**PLANNING COMMISSION HEARING DATE: APRIL 5, 2018  
AGENDA ITEM NO.: 2**

<b>Case Numbers</b>	<b>P14-1033</b> (Design Review), <b>P14-1034</b> (Lot Line Adjustment)		
<b>Request</b>	To consider an appeal of an approval by the Development Review Committee for a proposal by Art Day of Transition Properties, L.P. for a Design Review to construct a 308,000 square foot warehouse building, a Lot Line Adjustment to consolidate four parcels into one parcel, and related Mitigated Negative Declaration and Mitigation Monitoring and Reporting Program.		
<b>Applicant</b>	Karen Renfro on behalf of the Springbrook Heritage Alliance		
<b>Project Location</b>	3705-3667 Placentia Lane, located on the south side of Center Street, north side of Placentia Lane, between Orange and Main Streets		
<b>APN</b>	246-070-002, 246-070-017, 246-040-027, 246-040-028		
<b>Project area</b>	15.9 acres		
<b>Ward</b>	1		
<b>Neighborhood</b>	Northside		
<b>General Plan Designation</b>	B/OP – Business/Office Park

## CONDITIONS OF APPROVAL – Exhibit 1

Case Numbers: **P14-1033** (Design Review)  
**P14-1034** (Lot Consolidation)

PRELIMINARY ELEVATIONS

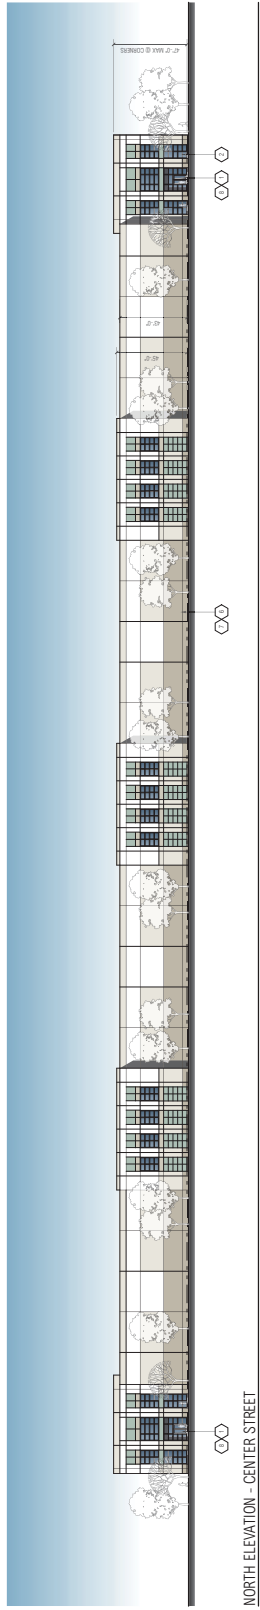
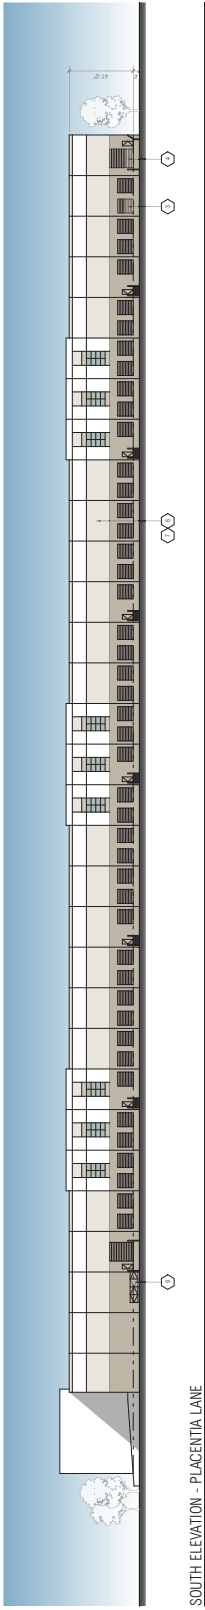
Staff has added conditions recommending ‘returns’ be added to office tower elements and panel sections that protrude higher than the main roof line adding visual interest and greater articulation. Additionally, staff recommends the westerly most south facing wall be enhanced and finished similar in architectural style to the office segments of the building. As conditioned, Staff supports the building elevations as they are consistent with recently constructed warehouse buildings located throughout the City and are consistent with the Citywide Design Guidelines.

19. **Staff Required Building Elevation Conditions:** Revise submitted building elevations such that the plans provided for building permit plan check incorporate the following changes;

- a. Where building walls protrude higher than the main roof line, returns shall be added.
  - b. The westerly most south facing wall be enhanced and finished similar in architectural style to the remainder of the building
